Item 4.**Development Application: 34-36 Oxford Street, Darlinghurst**

File No.: D/2017/1293

Summary**Date of Submission:** 27 September 2017

Figure 14: Photomontage of proposal viewed from Oxford Street

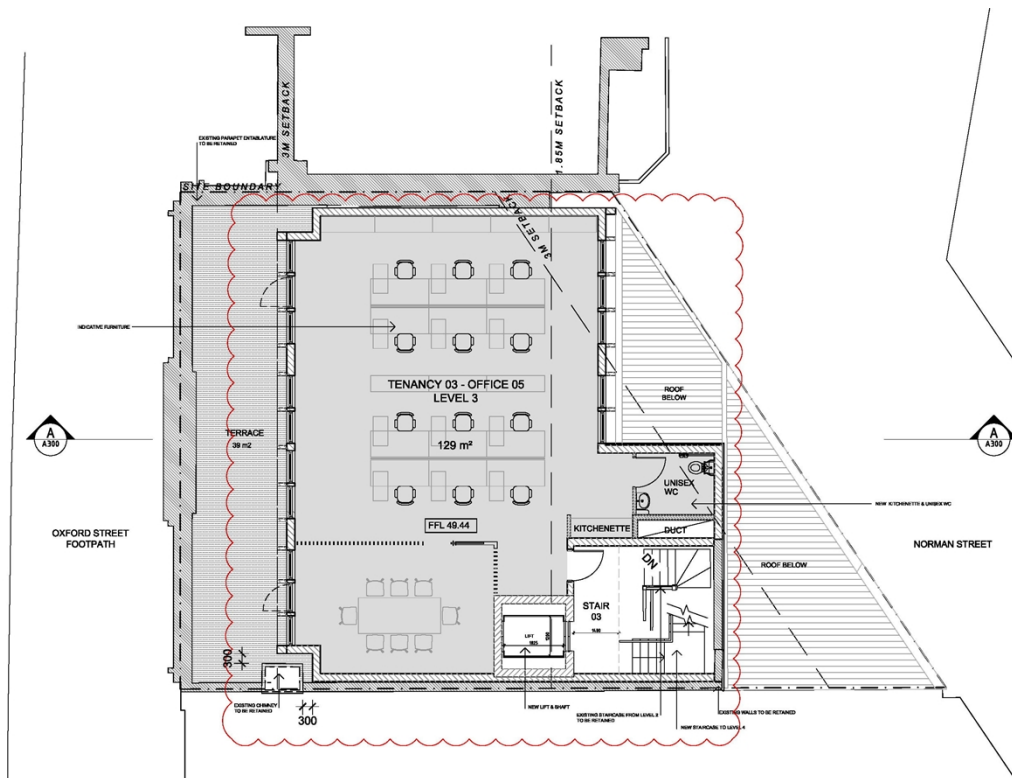
4.2.2 Building setbacks	Yes	<p>The proposed new floors will be setback 3m from the front property boundary. This setback is acceptable as it is consistent with the adjoining Park Apartments building to the west and maintains the setting of the heritage item.</p> <p>The additional floors are provided with a staggered setback from the rear property boundary of up to 6.8m in order to reduce the appearance of the addition when viewed from the rear.</p>

- (a) The additional height in the form of the two new levels will significantly impact on the heritage significance of the building and the streetscape. The setback is minimal and the addition will be visible from Oxford Street, Norman Street and surrounding buildings. Existing buildings on the northern side of Oxford Street have a uniform height and the proposed addition is inconsistent with this.

Response - The impact of the addition on the heritage item and conservation area has been discussed in the Issues section of this report. In summary, the proposed setback is considered to be acceptable given the site context, being adjacent to a tall tower (The Park Apartments) and the development controls for the site. In this regard, the proposed addition complies with the height in storeys control and building height control when viewed from Oxford Street. The proposal was amended to address initial concerns relating to the setback of the new addition and retention of existing chimney. The proposed addition has been assessed against the heritage provisions of the LEP and DCP and found to be acceptable.

Figure 15: Proposed level 3 floor plan. This floor plan is also typical of proposed level 4.

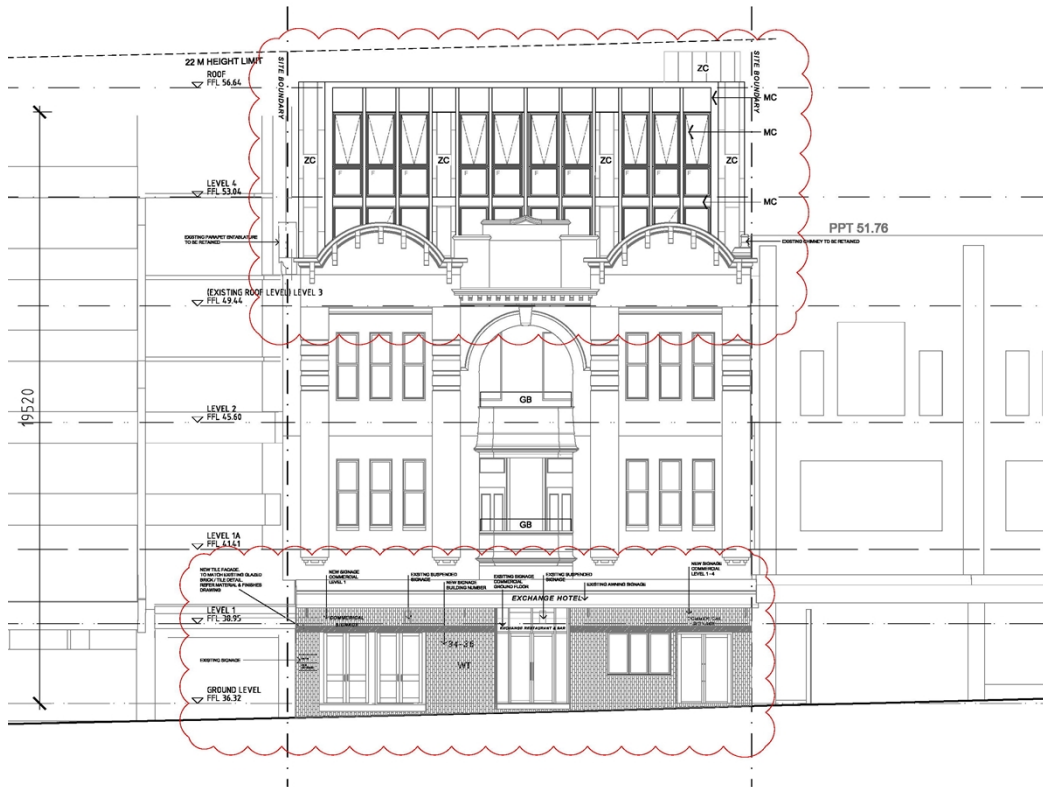
- (d) the floor plans should be reconsidered to create better arrangements of the internal spaces and rooms. For example rearrange the kitchen and toilet on the upper levels to avoid direct views into the spaces from the communal work space.

- (i) There is no indication as to what type of commercial use is proposed on the new levels. There is concern that the new levels will be used as an entertainment venue, as per the existing building.

Response - The Statement of Environmental Effects notes that the use of the proposed additional floors will be commercial office space and the submitted floor plans show the layout of an office on Levels 3 and 4.

Figure 16: Proposed front (Oxford Street) elevation

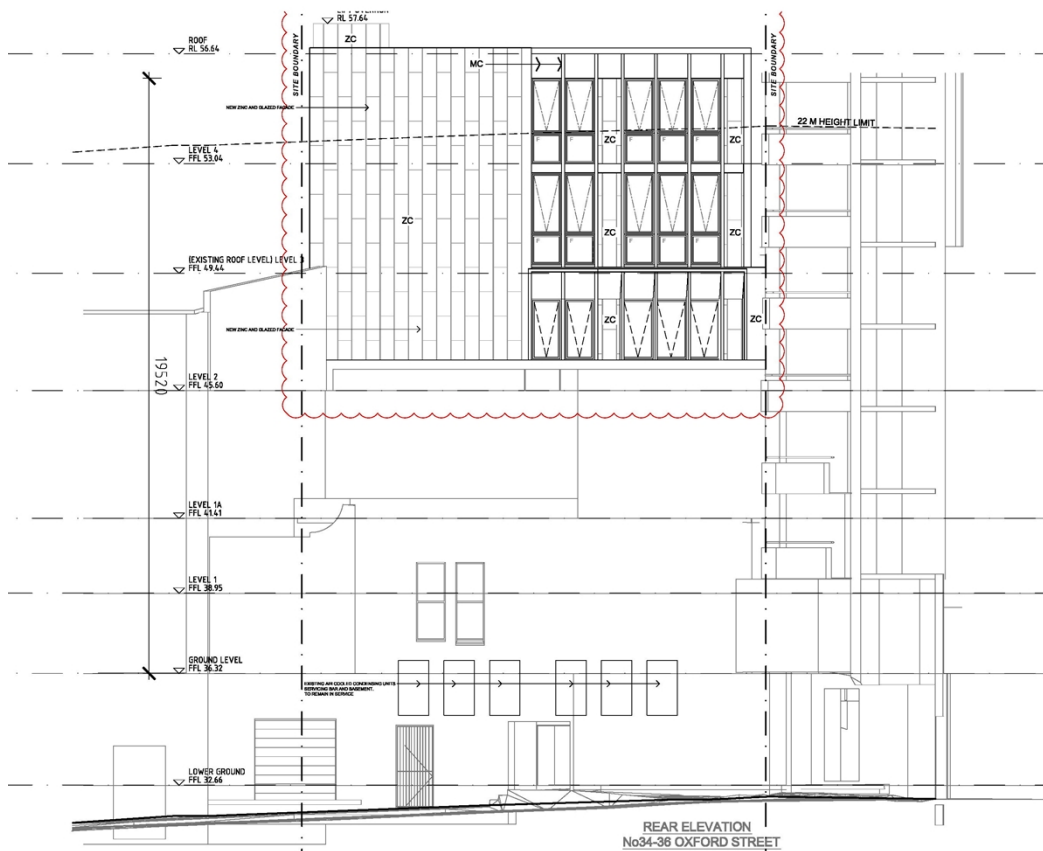
- (a) The southern façade should be recessed further than is currently proposed (to be in line with the adjacent building) the northern facade is acceptable,

- (b) increase the front setback of additional levels to a minimum of 3m to provide consistency with the setback of the adjoining Park Apartments building;
